Recommendations relating to Kimberley strengthening phase 3 scheme: Ferrum Mookodi 400 kV Line 2.

EWT has been requested by DIGES Group to review the adequacy and feasibility of the mitigation measures indicated in the avifauna reports. In the report EWT will make referrals to one document assessed; the avifaunal walkdown by The Biodiversity Company dated December 2024. EWT did not read recommendations made by Molepo (2020). EWT will also make any additional recommendations not in the avifaunal walkdown report.

Figure 1: Existing NTCSA power lines in and around Ferrum and Mookodi substations indicated by thin blue lines and the proposed Ferrum Mookodi power line indicated by think green line. In this project

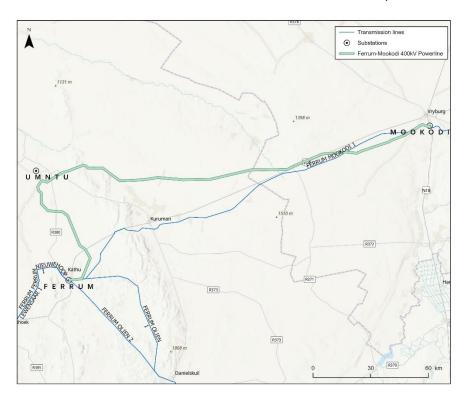
area, we recorded incidents of Cape Vulture, Lappet-faced Vulture and White-backed Vulture indicating the need for collision mitigation.

- The walkdown recommends that the entire power line or the parallel power line be installed with bird flight diverters. As mentioned in the walkdown report there are two vulture restaurants both at least 60km from the power line. Three vulture species use the project area intensively (based on previous site visits. (MO Mohale, based on previous visits on the northern side of the line). There have been a few records of the three species; Lappet-faced Vulture, Cape Vulture and White-backed Vulture. The common challenge faced by the vulture species with regards to high voltage (HV) power lines is collision. Electrocution is very rare on HV power lines due to large electrical spacing among live conductors and between live conductors and earthed structures.

- ➢ If for any reason the entire line cannot be marked, the spans near water from 202-319 must be installed with bird flight diverters especially where the power line crosses the river / water body. Towers 108 -201 where there are rocky ridges that may obscure the power line must be mitigated with bird flight diverters. Furthermore, there were many vultures observed in this section of the project area. In summary as per the two points above towers 108 to 319 are very high risk in addition to the line being high risk as per the avifaunal Site Ecological Importance.
